# **STRUCTURAL BARN EVALUATION**

**243 POST ROAD  
BOWDOINHAM, MAINE 04008**

*Submitted: October 5, 2020*

Project No. 20-0377-ME

**ROOF GIRDER REHAB OPTION A**  
 1/2" = 1'-0"

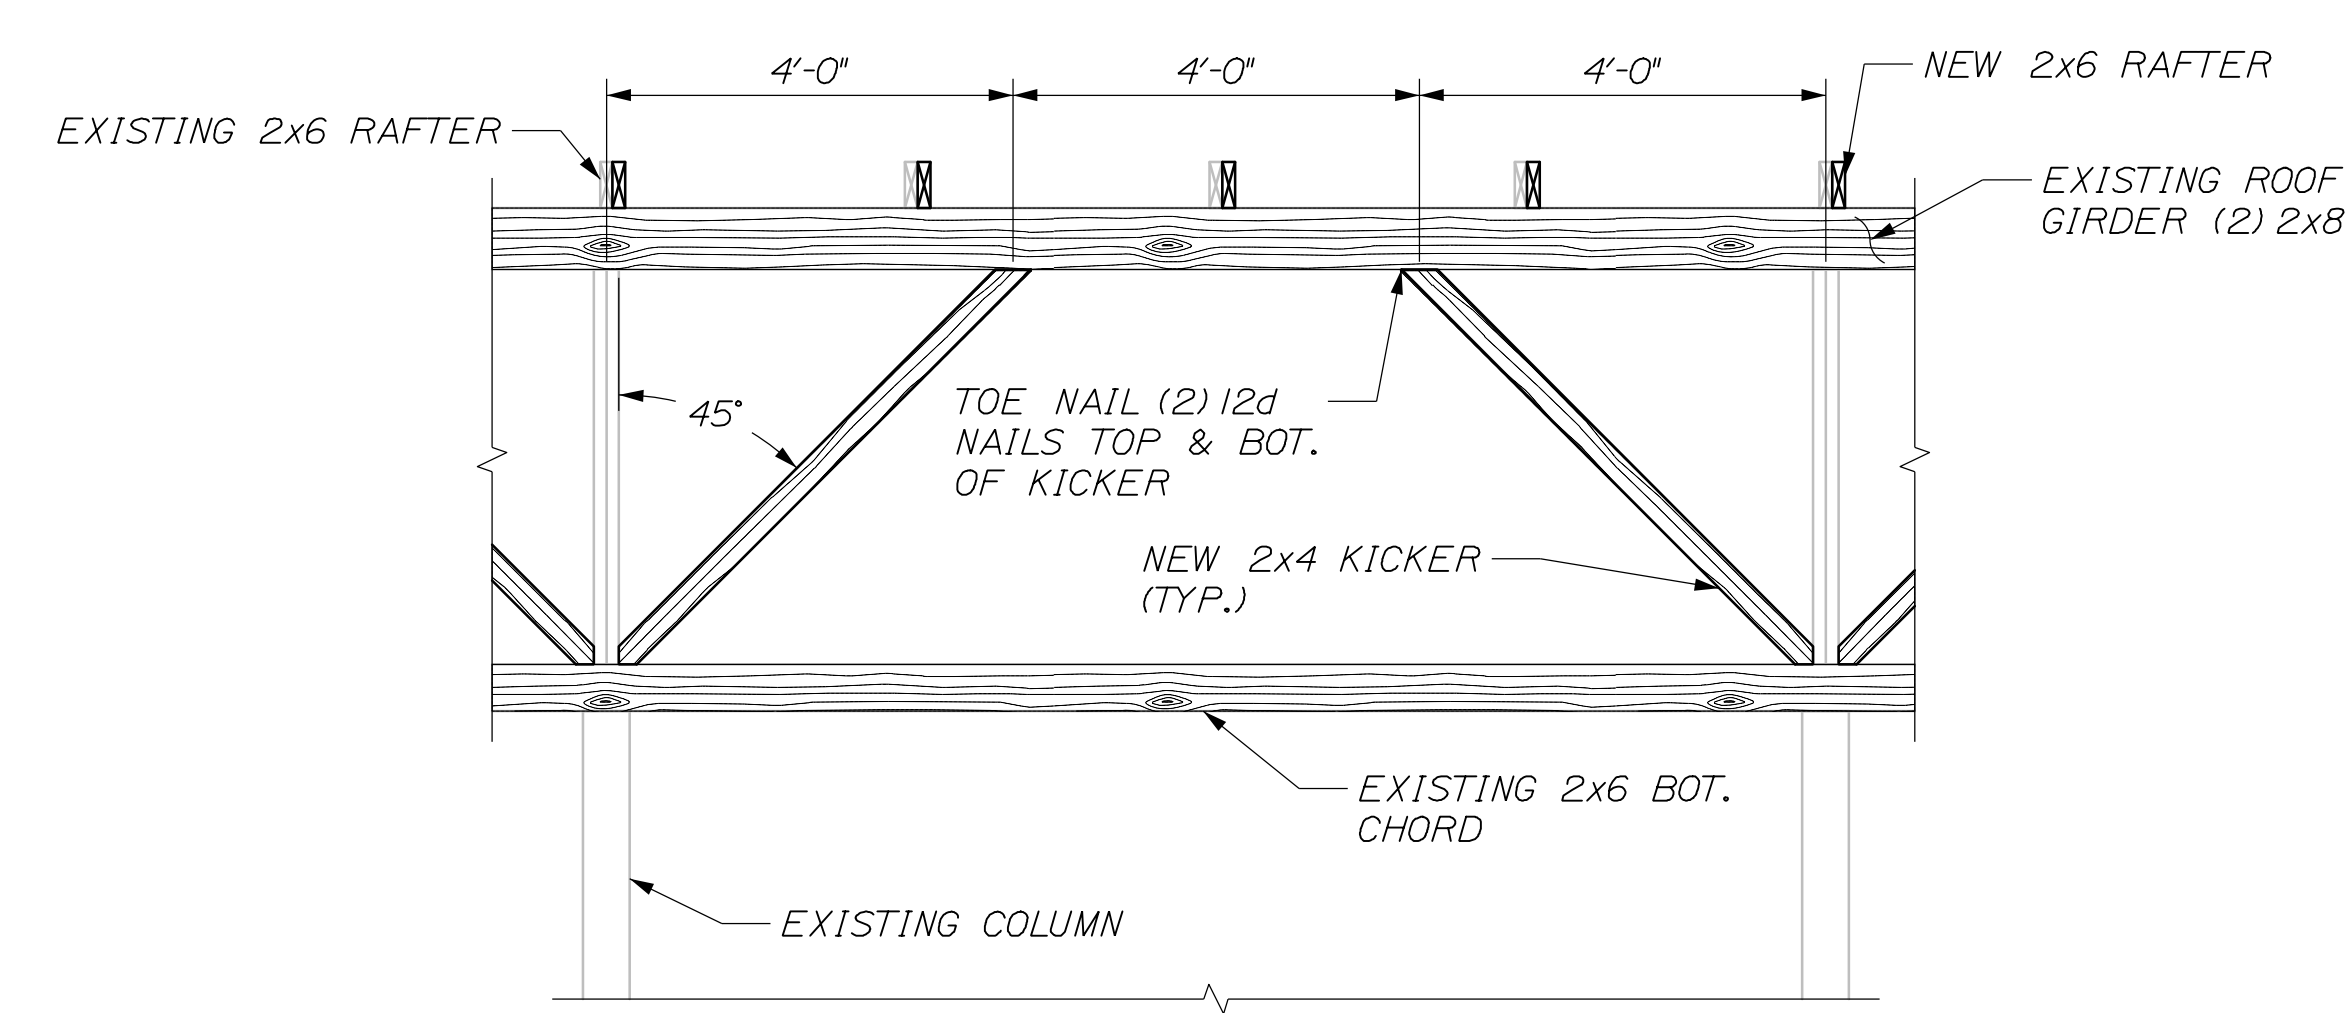
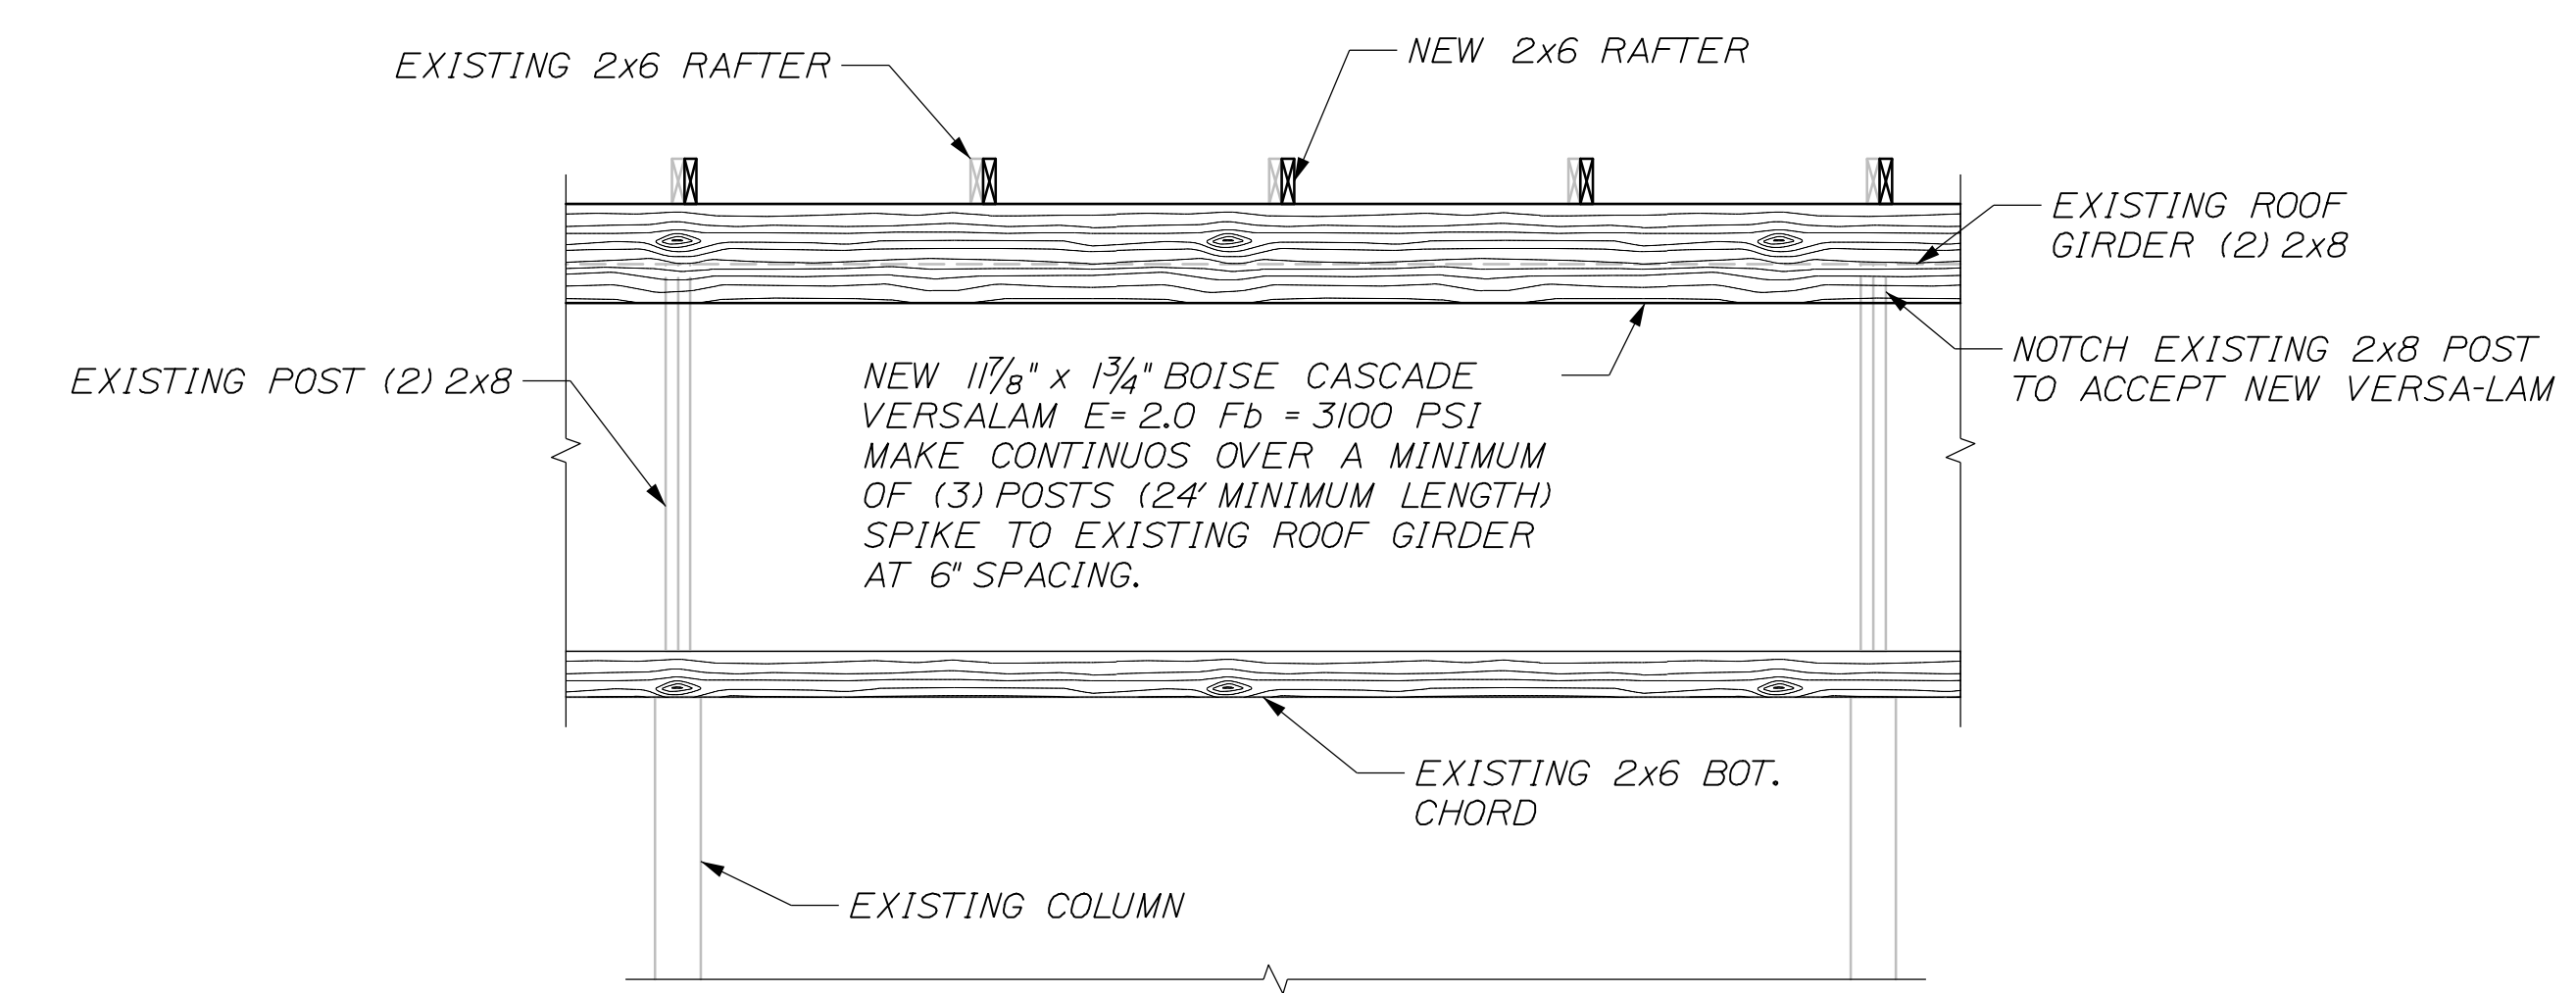
The CE design shows adding one 1.75"x11.25" Versalam to the beam supporting the rafters. I calculated the need for two Versalam beams; I assumed that the stronger and deeper material would take all the load from the 2x8s because the lower edge of the engineered lumber is taking the tension below the bottom of the 2x8s. This calculation should be checked.

The rafter beams are undersized, on both sides of the building. This is a typical problem with chicken barns. These can be sistered with LVLs (engineered lumber); and the beams should be

made adequate for the unbalanced snow load. My rough calculations showed that two LVLs were needed, rather than one, for each beam.

**EXISTING CEILING TRUSS**  
 $\frac{1}{2}'' = 1'-0''$   
 NOTE: EXISTING CEILING TRUSS FOUND IN REAR OF BUILDING

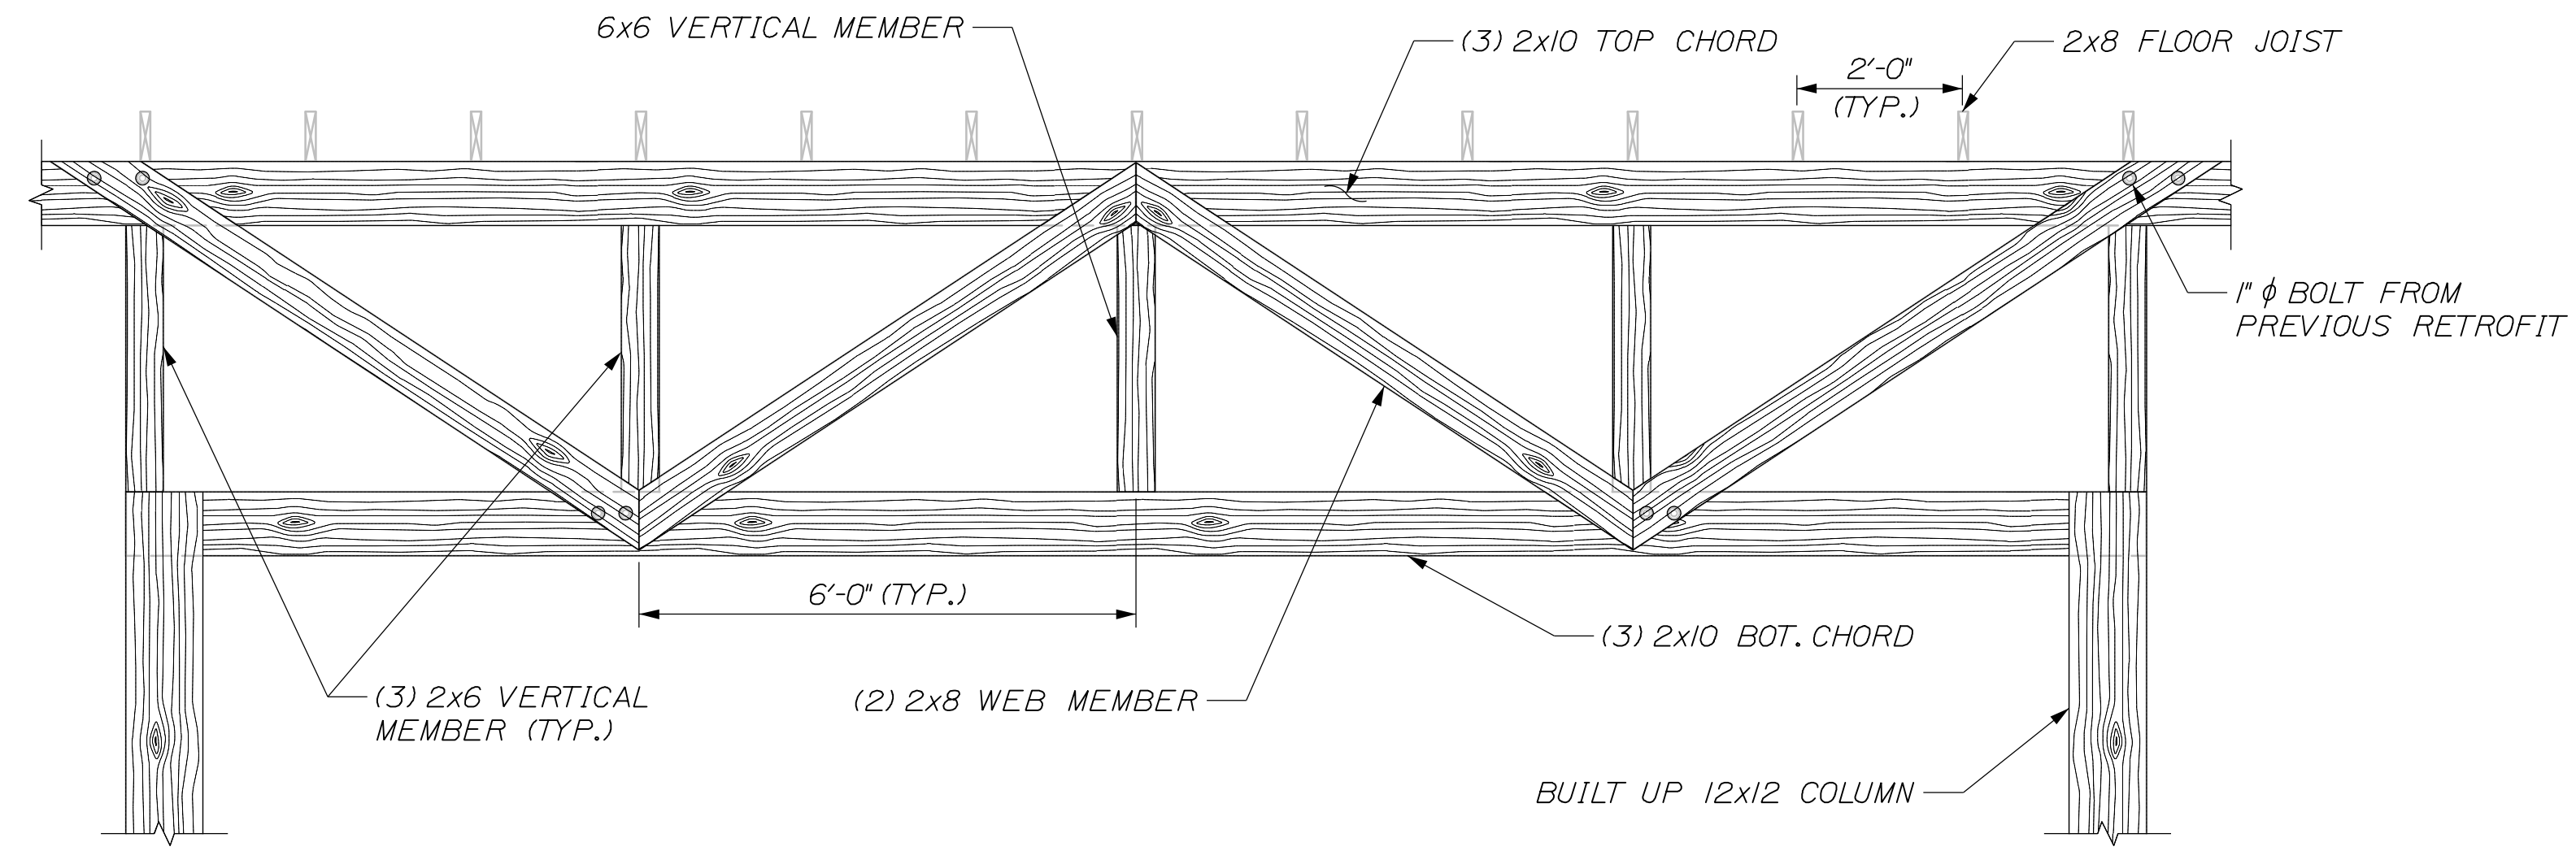
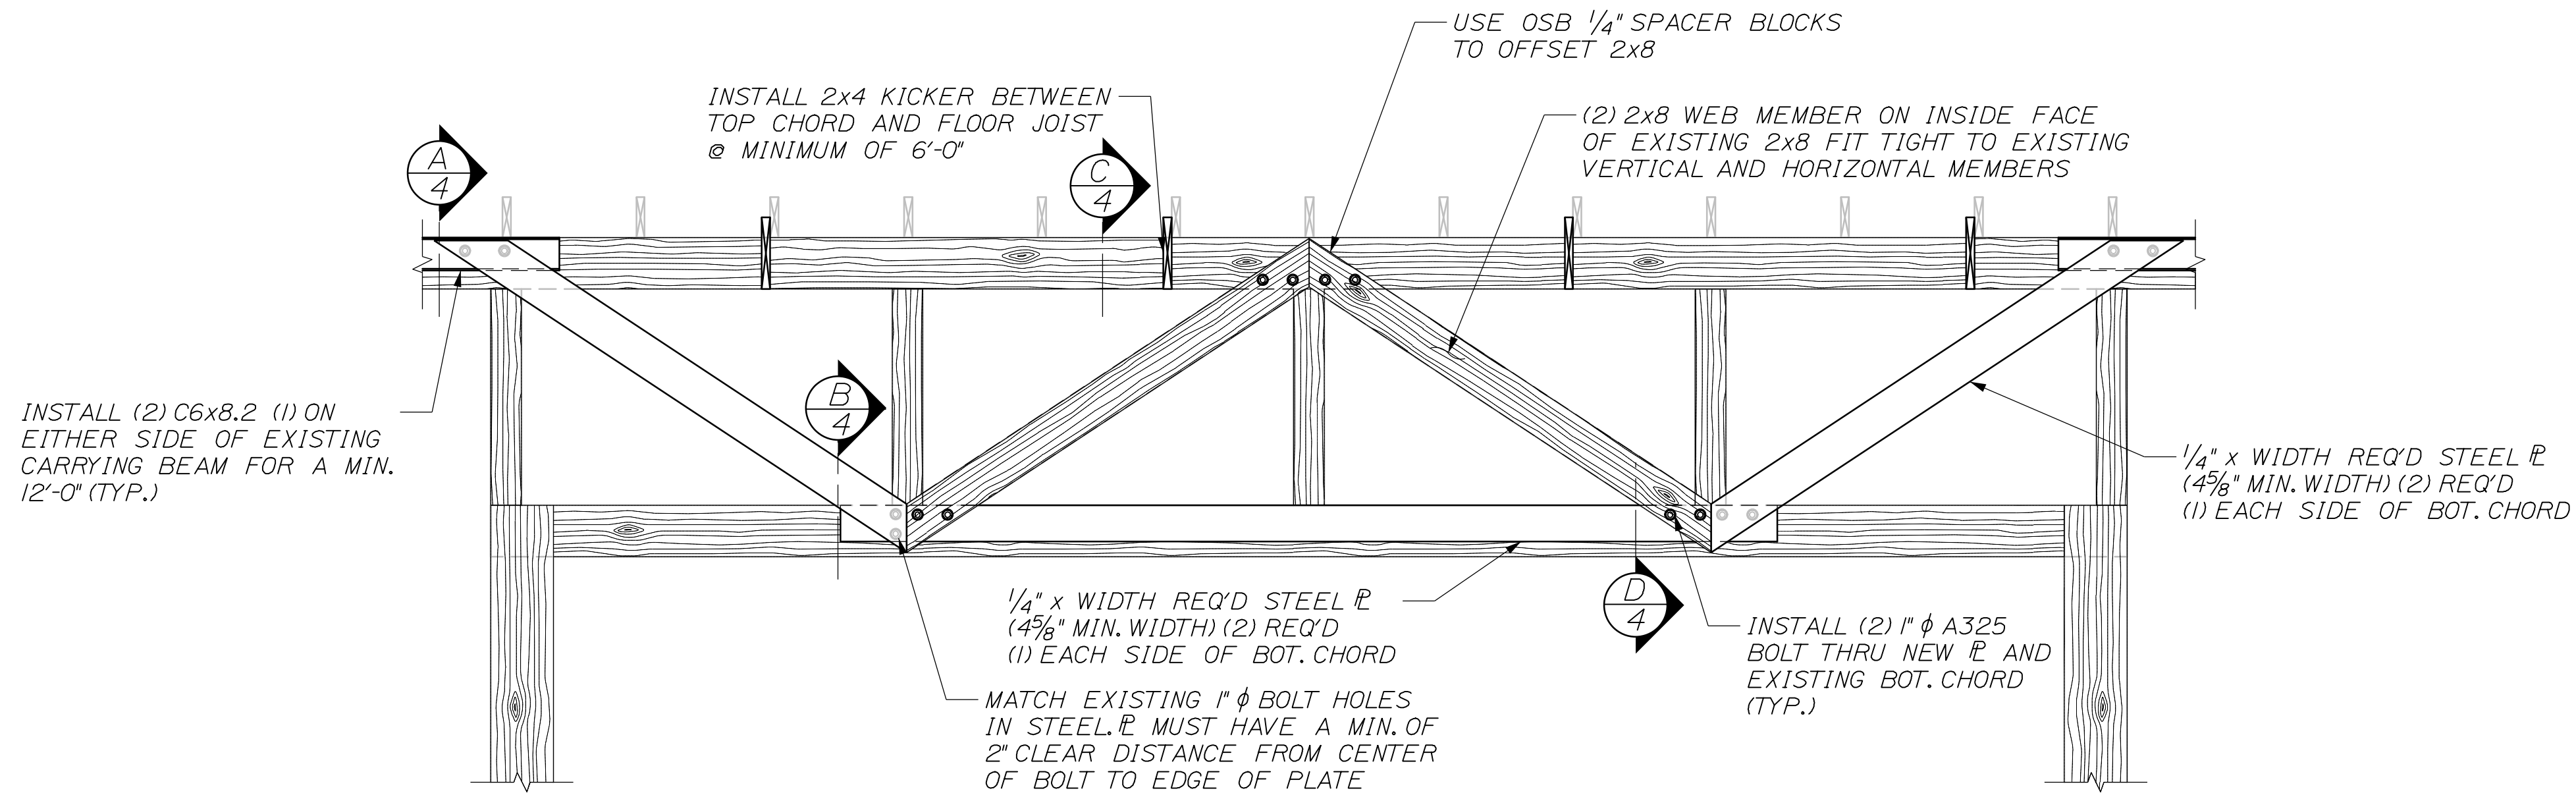
The CE design for the trusses uses some 1" diameter A325 bolts. These connections work well for steel-to-steel applications, but a steel-to-wood application should use more, smaller, connectors rather than one, larger, connector, to prevent wood failure at the joint.

The extensive repairs recommended for the large trusses at the east end of the building may be more simply addressed by installing a steel beam in these two locations, supported by the 12x12 columns as needed.
